Petition for Recommended Modifications to the Operable Unit 2 Groundwater Monitoring Plan, Northrop Grumman Corporation, Bethpage, New York (NYSDEC Site #1-30-003A).

Date:  
3 June 2004

NORTHROP GRUMMAN CORP.  
 BETHPAGE, NEW YORK

RECOMMENDED MODIFICATIONS  
 TO OPERABLE UNIT 2  
 GROUNDWATER MONITORING  
 PLAN

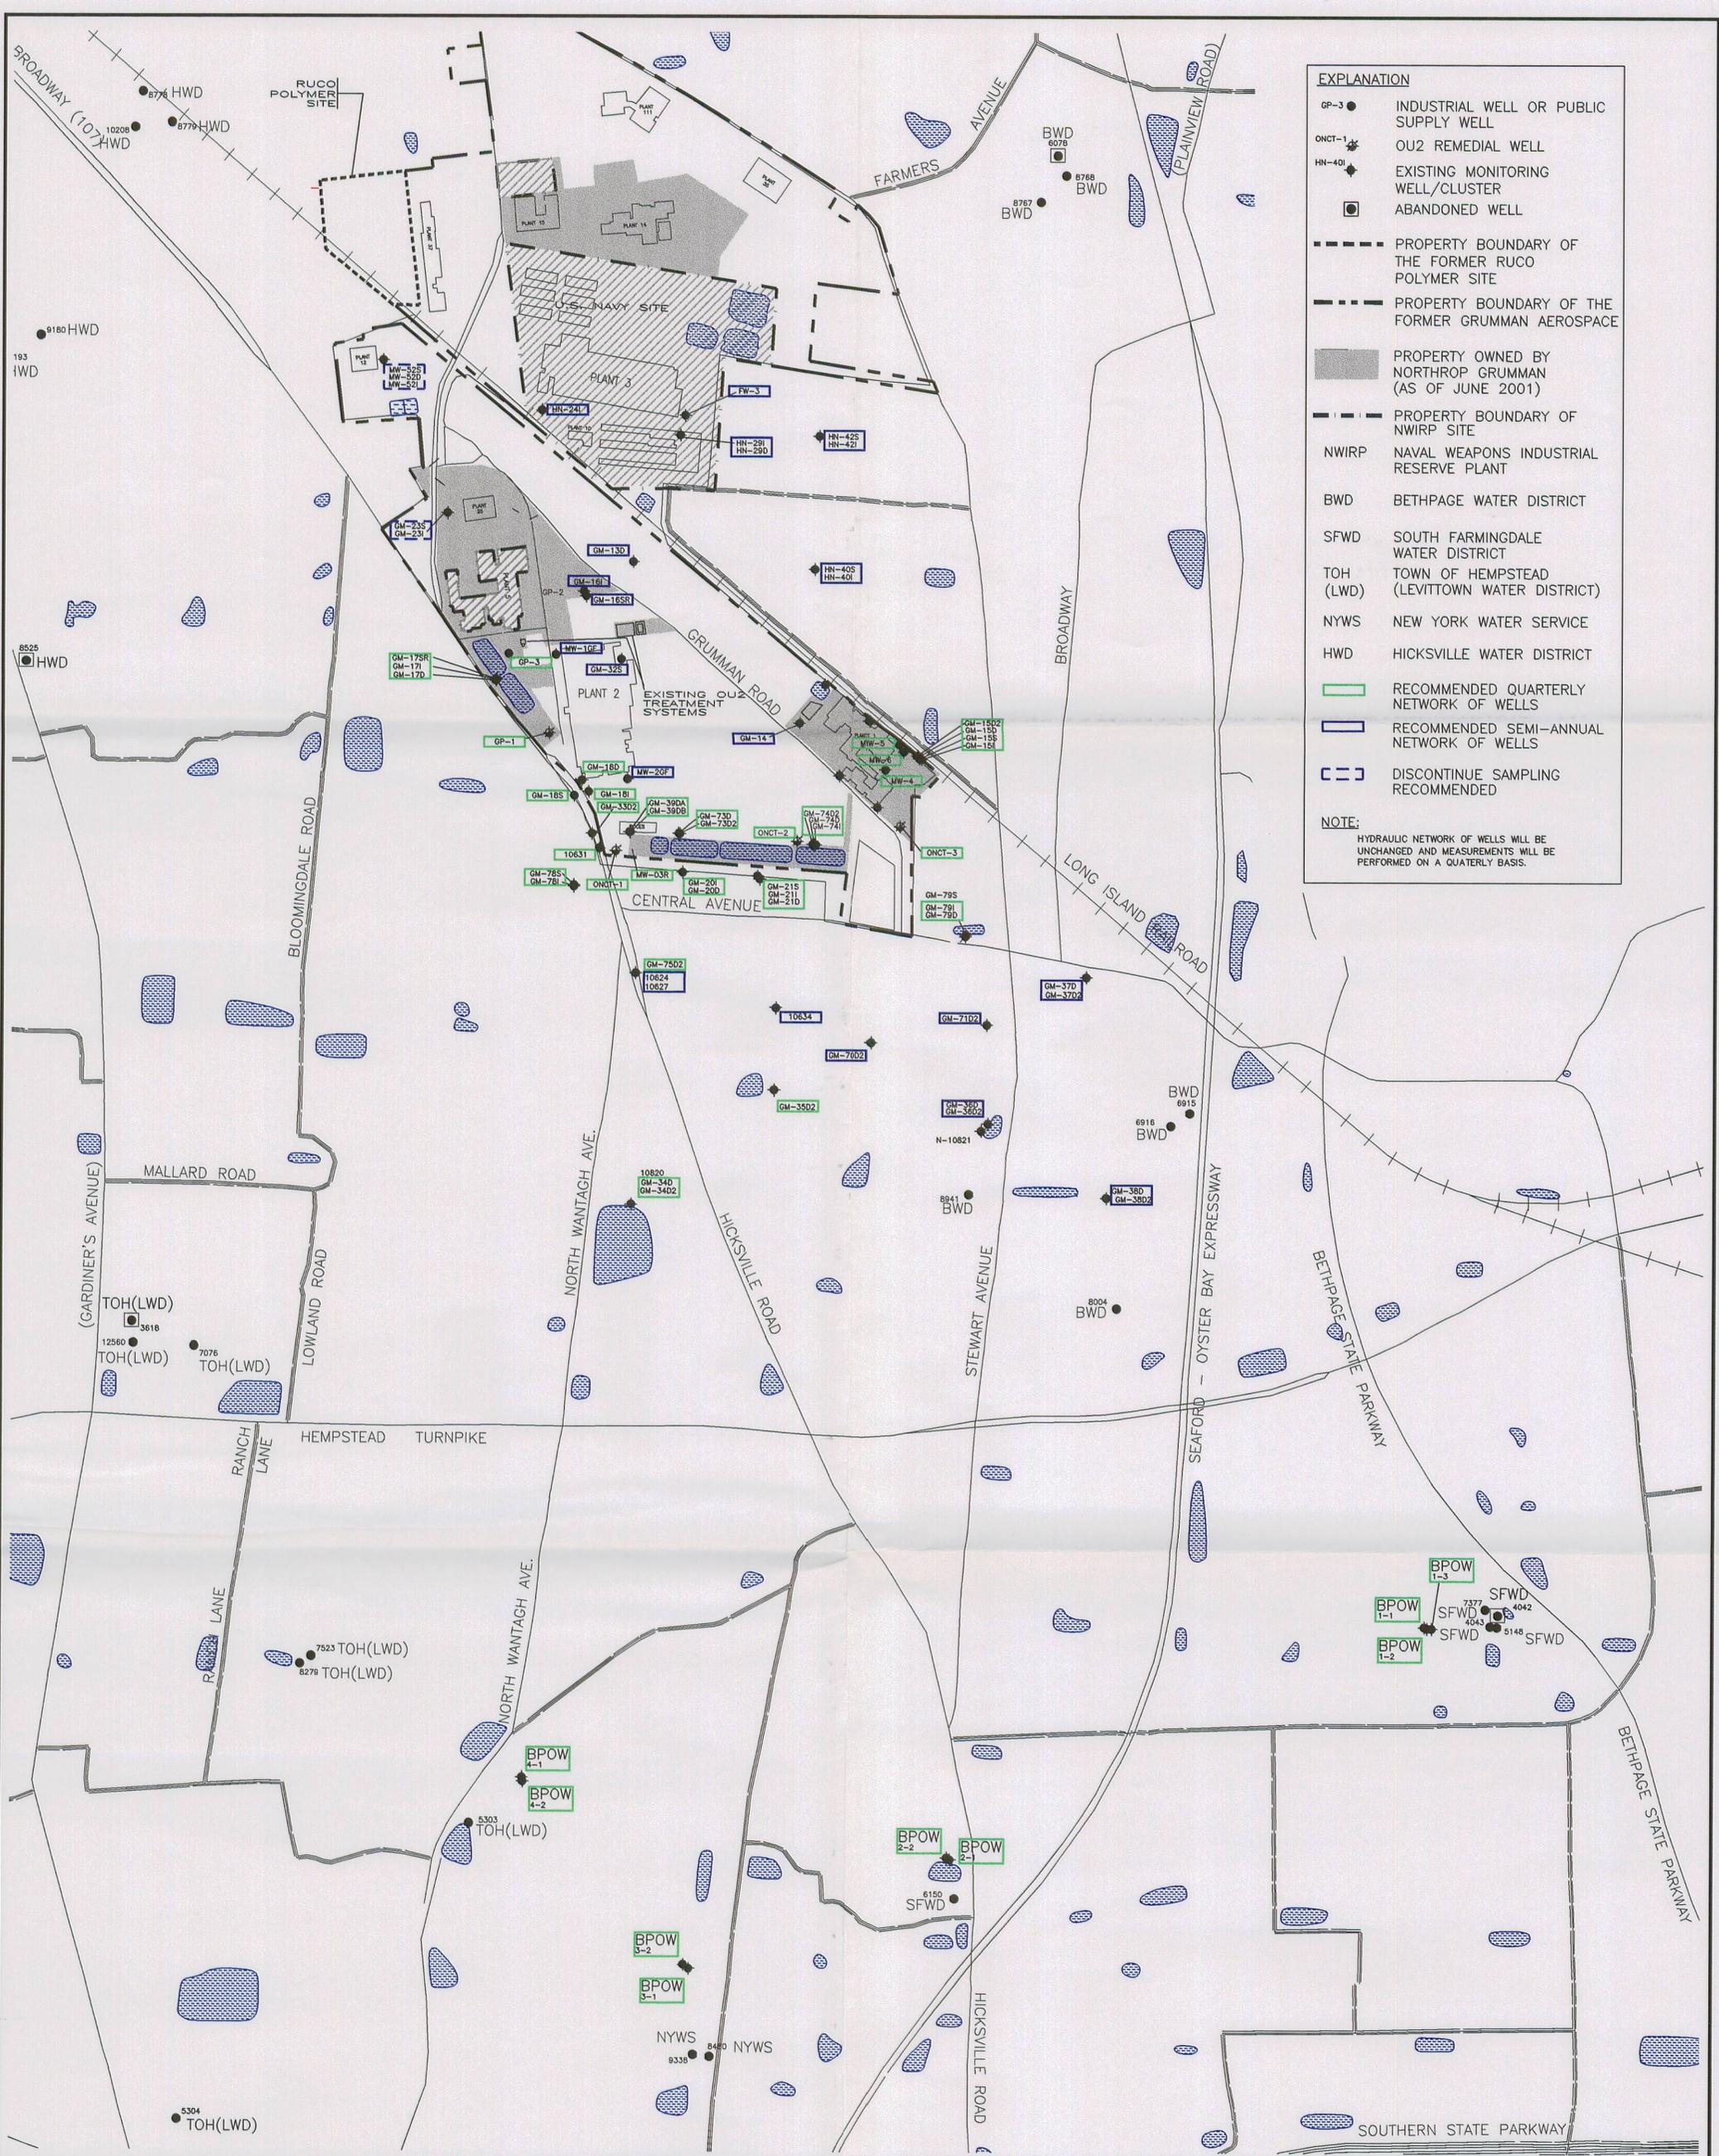
The recommendations were developed based on data developed from the current network, which consists of monitoring wells, remedial wells, and Industrial Well GP-3, for a grand total of 90 wells sampled for groundwater quality monitoring purposes. Groundwater sampling has been ongoing on a quarterly basis since the startup of the OU2 Groundwater Remedy in November 1998 (initially the OU2 groundwater interim remedial measure [IRM]). Before the startup of the IRM, groundwater sampling had been conducted in subsets of wells since 1994. Collectively, the period of record of groundwater quality monitoring data for the volatile organic compound (VOC) groundwater plume clearly demonstrates that a substantial amount of data has been collected and evaluated over the past decade. Furthermore, the recently-completed OU2 Hydraulic Effectiveness Evaluation Report (ARCADIS G&M, Inc. 2003) clearly demonstrated that the on-site portion of the OU2 Groundwater Remedy is effective in preventing the off-site migration of VOCs. ARCADIS therefore believes that modification of the groundwater sampling frequency as specified in Table 1 and on Figure 1 (enclosed) is warranted at this time.

**NOTE:**  
HYDRAULIC NETWORK OF WELLS WILL BE UNCHANGED AND MEASUREMENTS WILL BE PERFORMED ON A QUARTERLY BASIS.
